Source: SA WG3
Title: CR to 33.107: The use of H.248 in setting up a bearer intercept point at the MGW (Rel-5)
Document for: Approval
Agenda Item: 7.3.3

SA doc#	Spec	CR	R	Phase	Subject	Cat	Current Version	SA WG3 doc#
SP-020110	33.107	018		Rel-5	The use of H.248 in setting up a bearer intercept point at the MGW	B	5.1.0	S3-020072

Tdoc S3LI02_025r2

Figure D.2: Mobile to Mobile call originating side is target

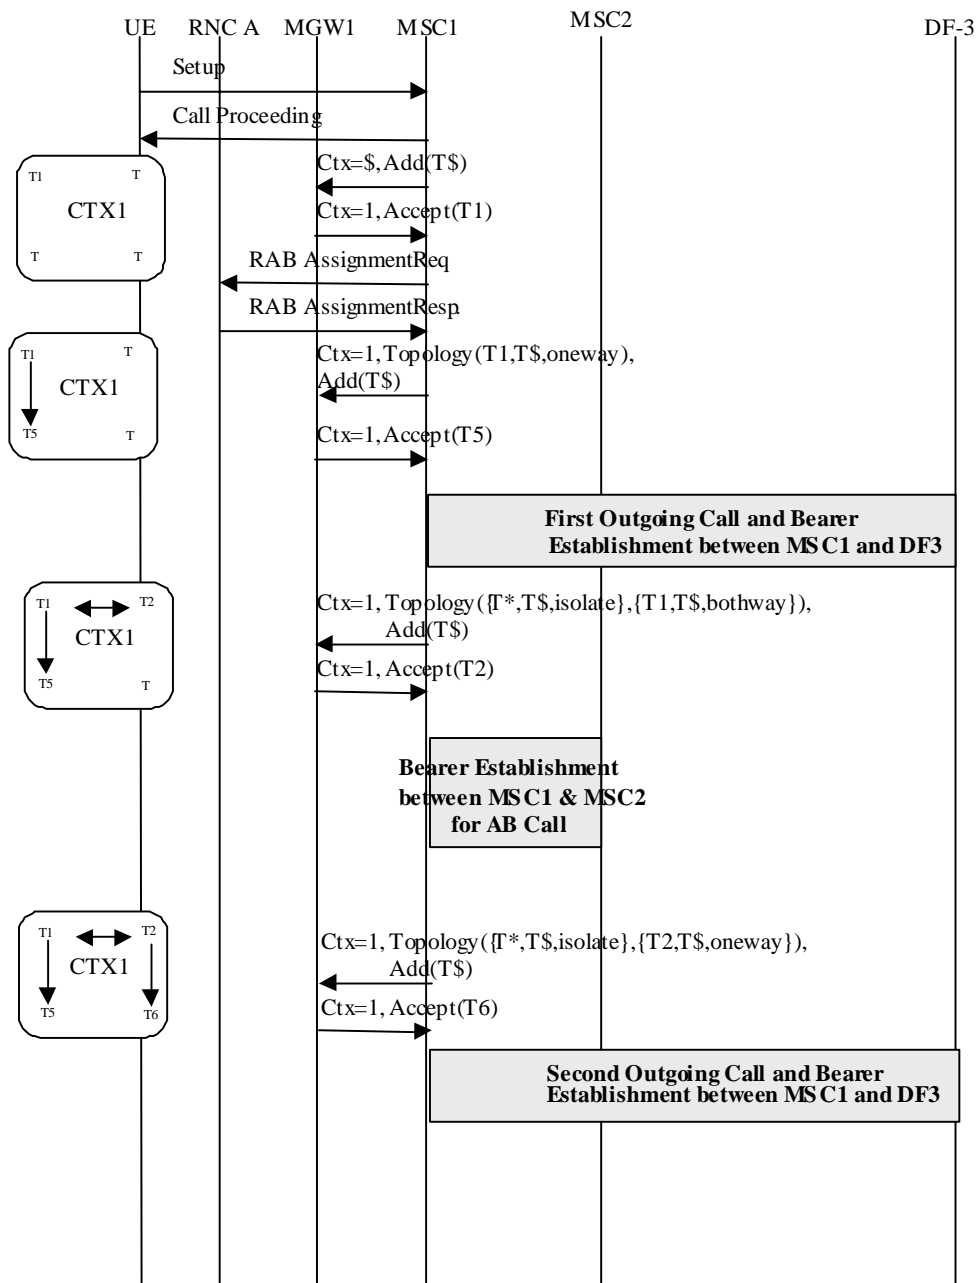
Reason for change:	⌘ Additional explanation regarding the usage of H.248 in setting up a bearer intercept point at the MGW.
Summary of change:	⌘ Additional annex for the H.248 call flows.
Consequences if not approved:	⌘ H.248 interception flows will be missing from the specification
